From: [Steve Donnelly](#)
To: [EPD, Customer Services](#)
Subject: COMM - Jemena - 201835109 - Block 21 Section 30 Dickson
Date: Tuesday, 22 January 2019 8:53:47 AM
Attachments: [image001.png](#)
[image002.jpg](#)
[22012019085326-0001.pdf](#)

Gas Networks Statement of CONDITIONAL COMPLIANCE

DEVELOPMENT APPLICATION NO: 201835109
BLOCK: 21 **SECTION:** 30 **DIVISION:** DICKSON

DEVELOPMENT APPLICATION NO: 201835109

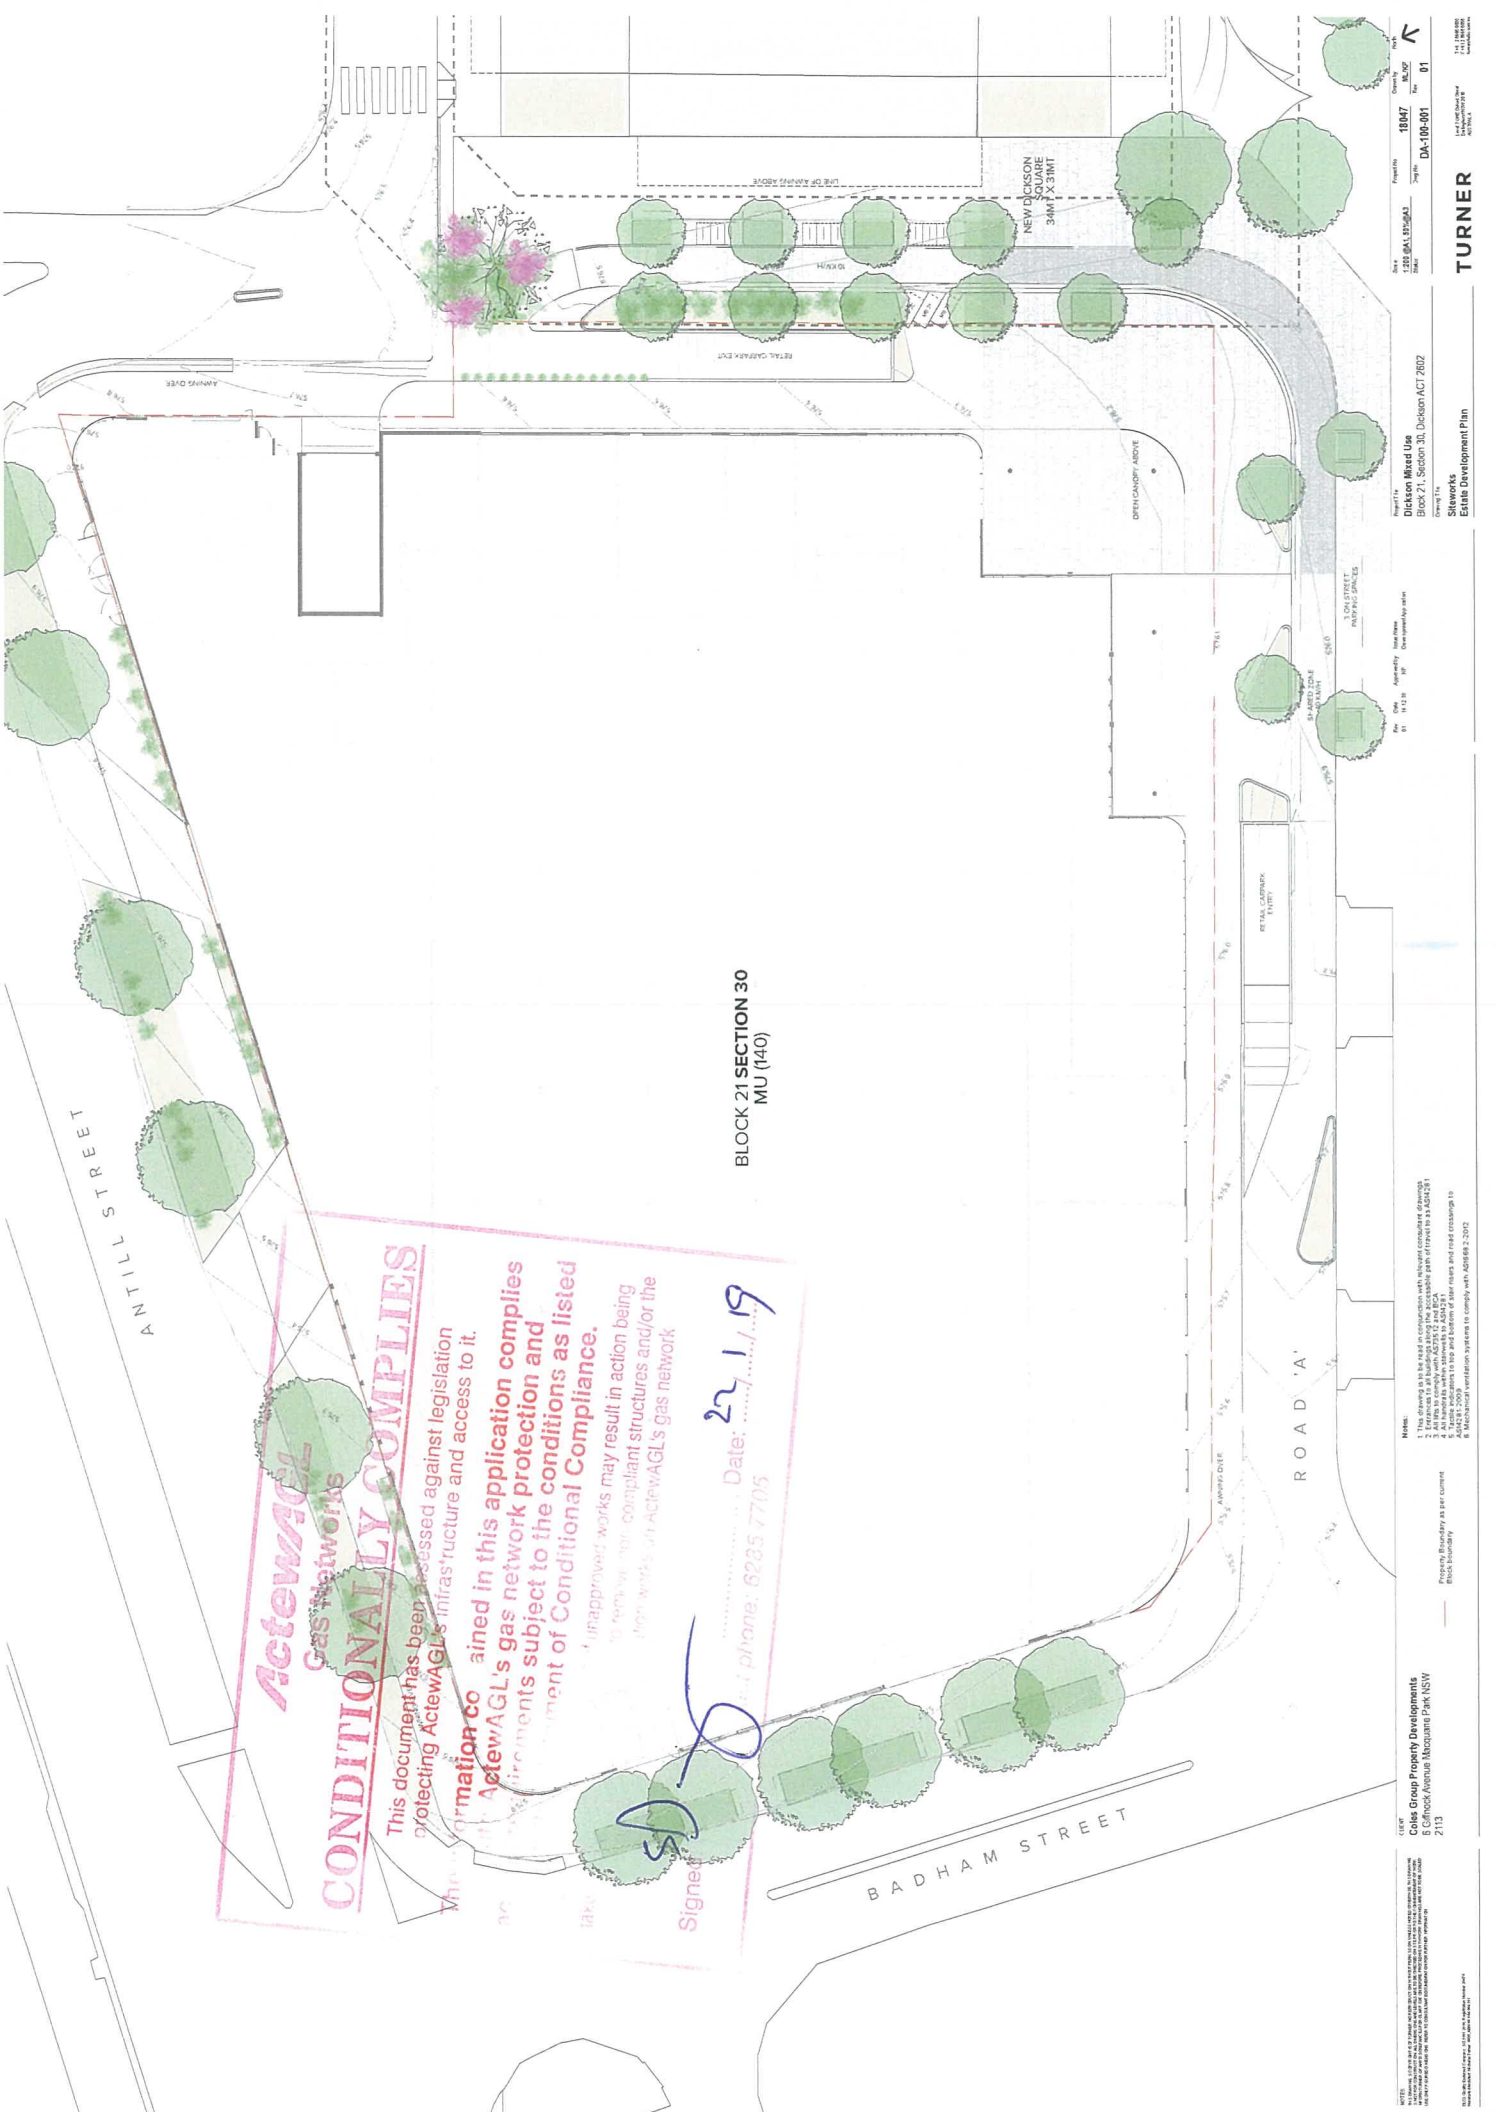
CONDITIONALLY COBBLE'S

This document has been assessed against legislation protecting ActewAGL's infrastructure and access to it. The information contained in this application complies with ActewAGL's gas network protection and safety requirements subject to the conditions as stated in the Statement of Conditional Compliance. Completion of unapproved works may result in a flow being cut to remove gas to protect infrastructure and/or the safety of the public. ActewAGL's network is a critical infrastructure asset.
